APPLICATION NO.	FILING DATE	FIRST NAMED INVENTOR	ATTORNEY DOCKET NO.	CONFIRMATION NO.
10/659,736	09/10/2003	Gary M. Richter	023720-0338	3906

Office Action Summary

This is the first office action for application number 10/659,736, Merchandising System, filed on September 10, 2003.

FIG. 1

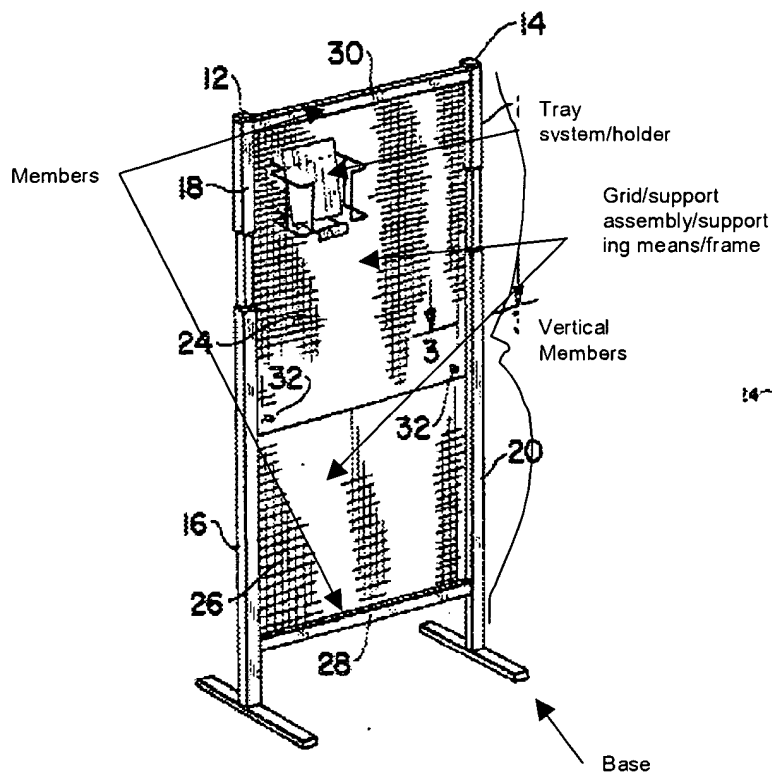
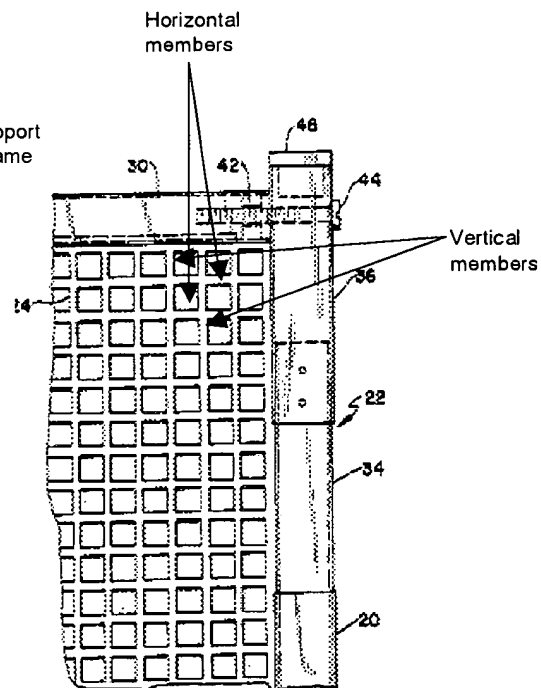
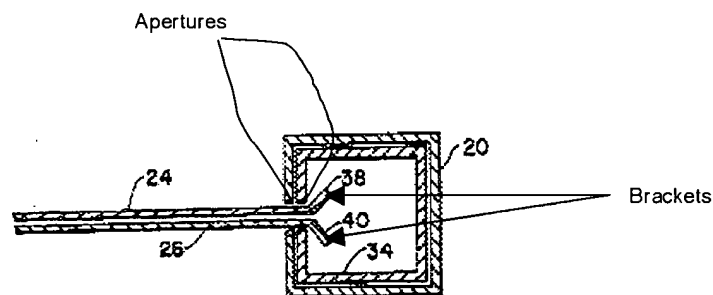
Claims 1-2, 5-12, 18-23 and 25-34 are rejected under 35 U.S.C. 102(b) as being anticipated by U.S. Patent number 4,127,196 to Boucher.

Boucher '196 discloses a system (above) comprising a grid/support assembly/supporting means/frame (above) comprising a plurality of vertical and horizontal members (above) coupled to each other and arranged in a generally planar configuration and oriented so that one or more tray systems/holders (above, a "tray" is

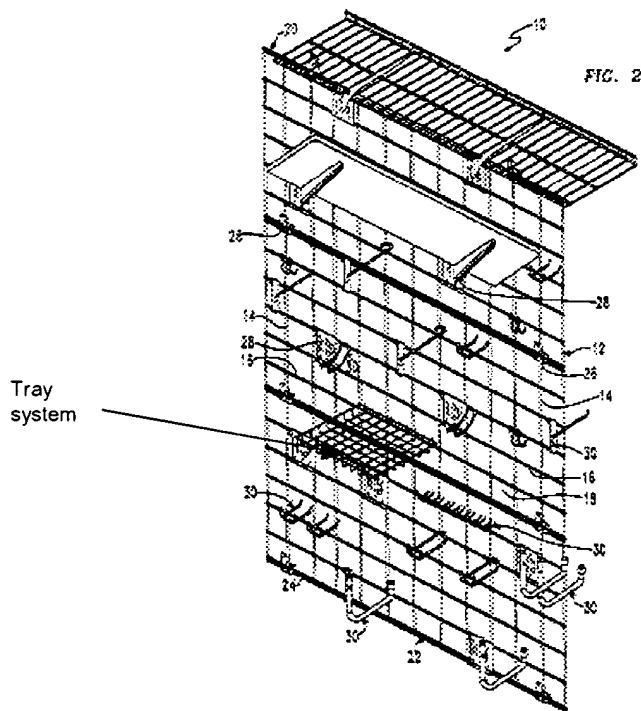
Claims 1, 2, 12 and 17 are rejected under 35 U.S.C. 102(e) as being anticipated by U.S. Patent number 6,299,001 to Frolov et al.

Frolov et al. '001 discloses a system (above) comprising a grid (12) comprising a plurality of vertical and horizontal members (14,16) arranged in a generally planar configuration and oriented so that one or more tray systems (above) may be attached to the grid at select locations, and members (24, column 3, lines 60-63) coupled to the grid and inherently providing support to the grid to maintain the generally planar
